THE CITY OF WALTHAM
MASSACHUSETTS

Construction of the Lazazzero Park and Monsignor McCabe Playground

ADDENDUM NO. 3

December 8, 2011

Drawing Title:
MONSIGNOR MCCABE PLAYGROUND LAYOUT & MATERIALS PLAN

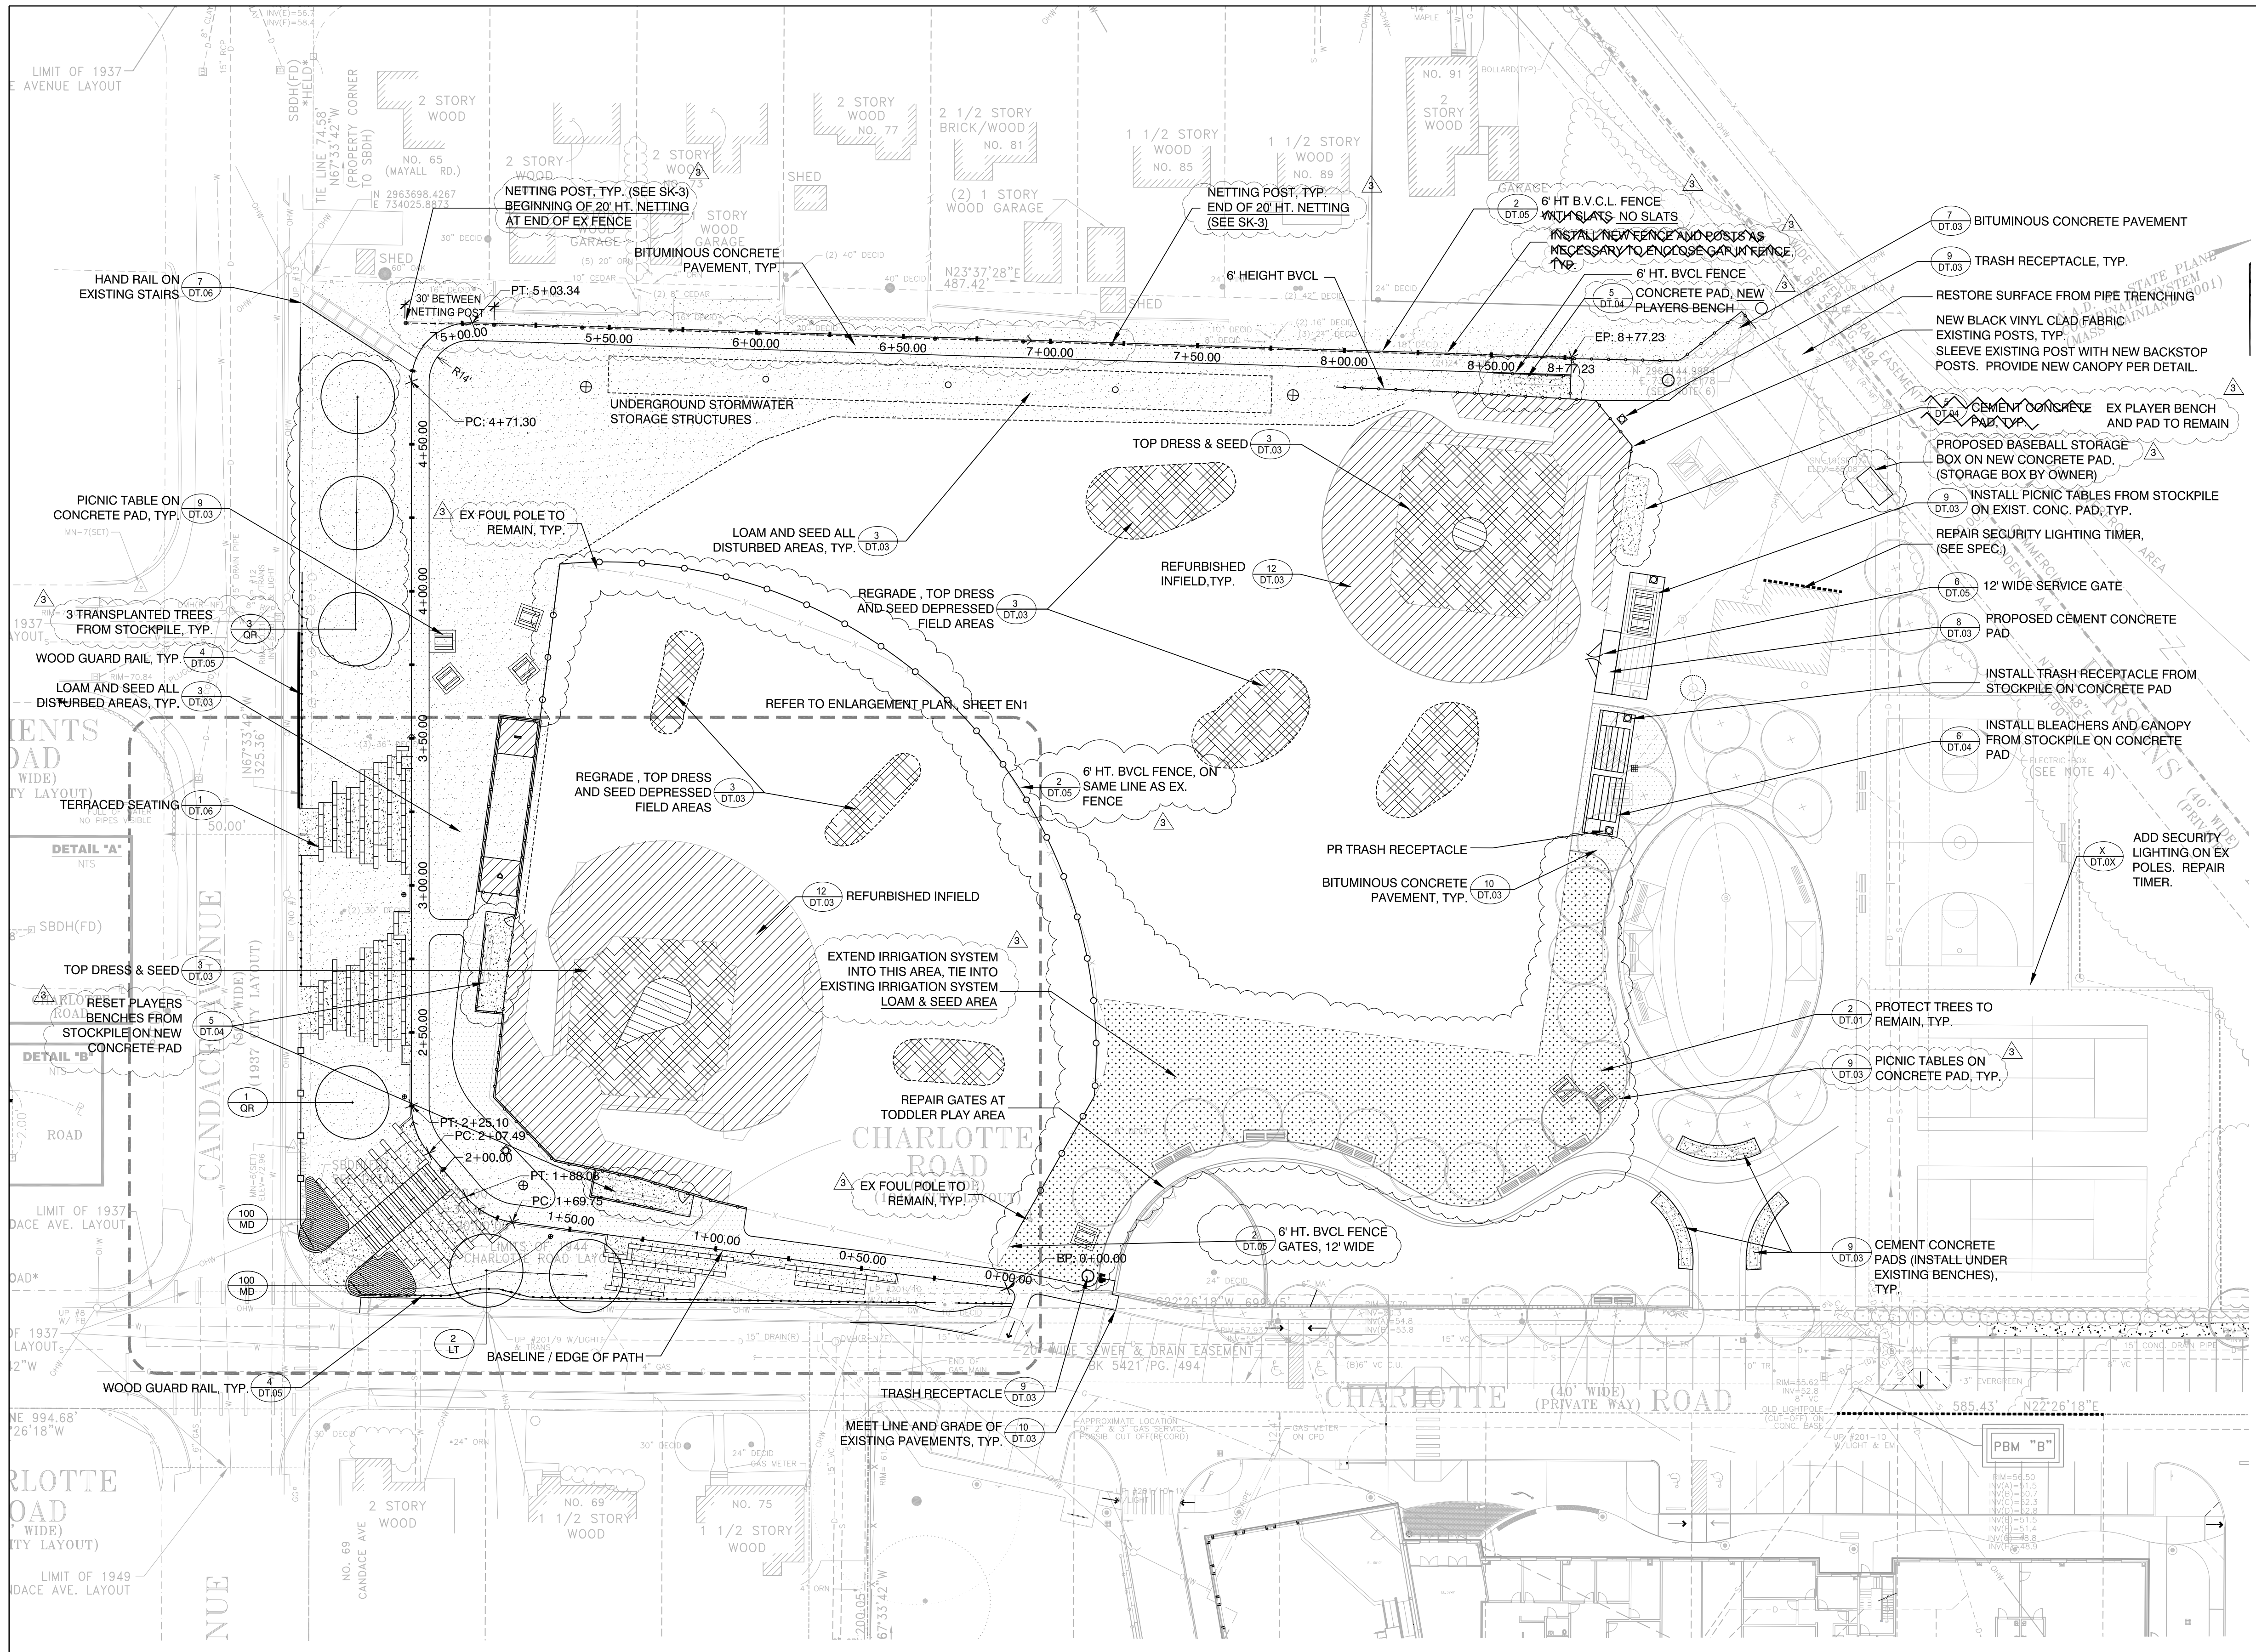
19. Question: Spec 02220 references demo of players benches with footings and concrete bleachers, both of which I don't see on the drawings. Are we to include demo of either of these, and if so how many of each?

25. Question: Sheet M-LM1 says to extend irrigation into "this" area. Please provide limits of new irrigation.

27. Question: Drawing M-SP1 calls out to transplant three trees. Where are the trees are to be transplanted?

28. Question: Drawing M-SP1 mentions to R&D CLF fabric only. Please provide the limits to where this begins and ends.

48. Question: M-SP1 Does not seem to indicate that we are to R & D the fence on the western property line (10' CLF?) but sheet M-LM1 seems to indicate we are to install a new 6' fence with privacy slats. Are we removing the existing fence and is it in fact 10' high?

Answer: There is a concrete bleacher to be removed at Lazazero Park. There are two benches at McCabe that will be removed and reset on the southern field, and one that will be removed and disposed at the northern field. Refer to attached revised sheet M-LM1.

Answer: Refer to the attached revised sheet M-LM1.

Answer: Refer to the attached revised sheet M-LM1.

Answer: Refer to the attached revised sheet M-LM1 for changes and clarification.

Answer: Yes, See attached revised sheet M-LM1

**CEMENT CONCRETE STAIRS
 AT TERRACE AREA
 (LAZAZZERO PARK)**

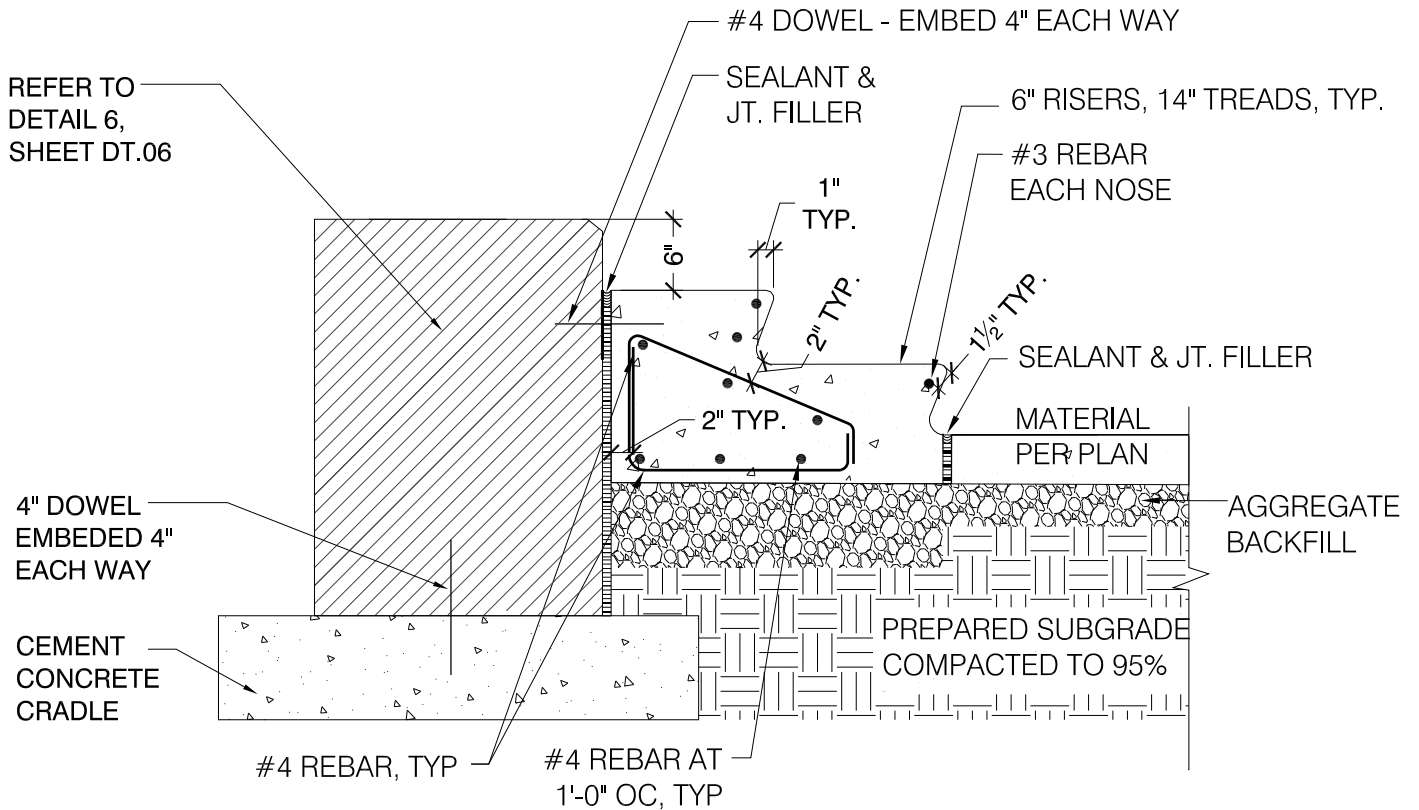
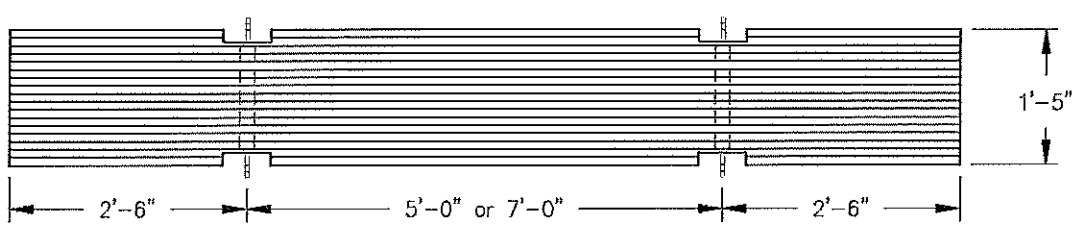
5. Question: What is the detail for the two sets of concrete stairs on sheet L-LM1?

Answer: See attached SK-1 Detail

1. ALL HANDRAILS SHALL BE 1-1/2" O.D. STEEL (FINISH SHOP GALVINIZED).
2. WHERE NOTED HANDRAILS SHALL BE CORE DRILLED AND SET WITH EPOXY GROUT.
3. ALL WELDS SHALL BE GROUND DOWN CLEAN AND SMOOTH.
4. ALL DIMENSIONS SHALL BE FIELD VERIFIED AND ADJUSTED AS NEEDED.

Plan View

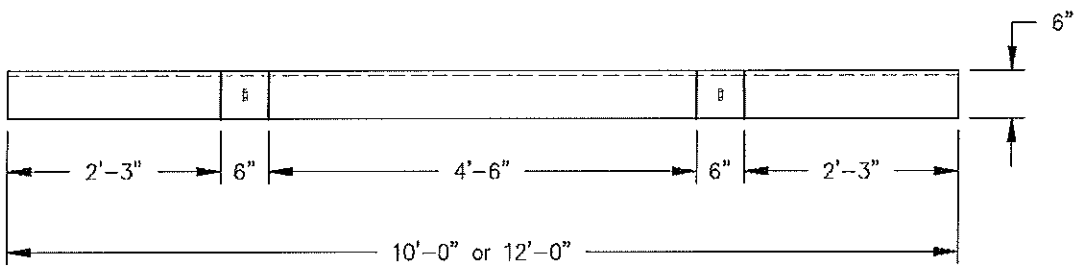
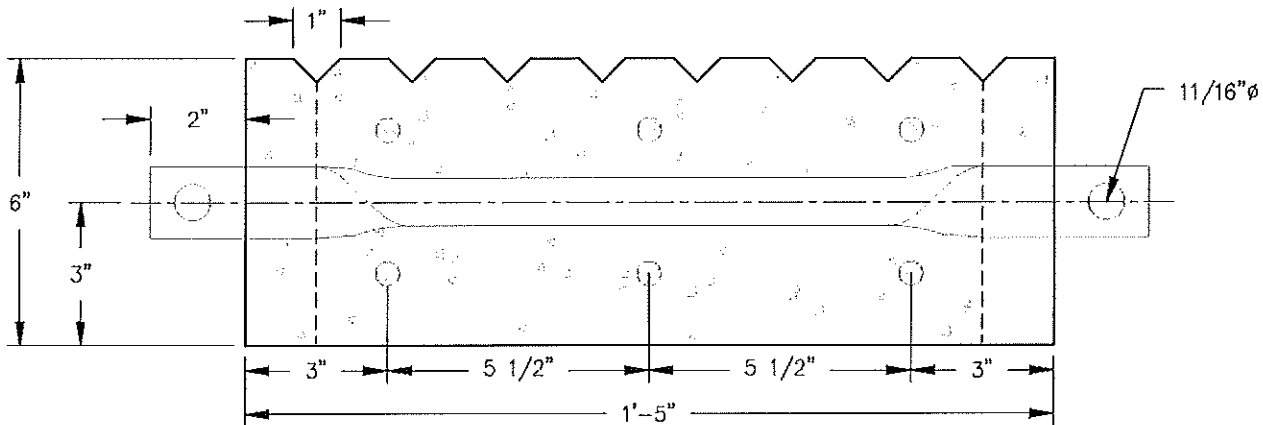
10. Question: There is no specification for the pier or boat ramp. Please provide.

35. Question: Can a plan view enlargement of the boat ramp be made available? Is it correct to use spec section 03410 Precast curb and block for this item or will a spec section be provided?

Answer: The boat ramp "precast concrete treads" shall be Articulated Concrete Mats" as supplied by the following manufacturers, or approved equal:

Install per manufacturers specifications. Refer to attached sheet SK-2 for further detail information.

Answer: No, see answer to question 10, and attached SK-2.
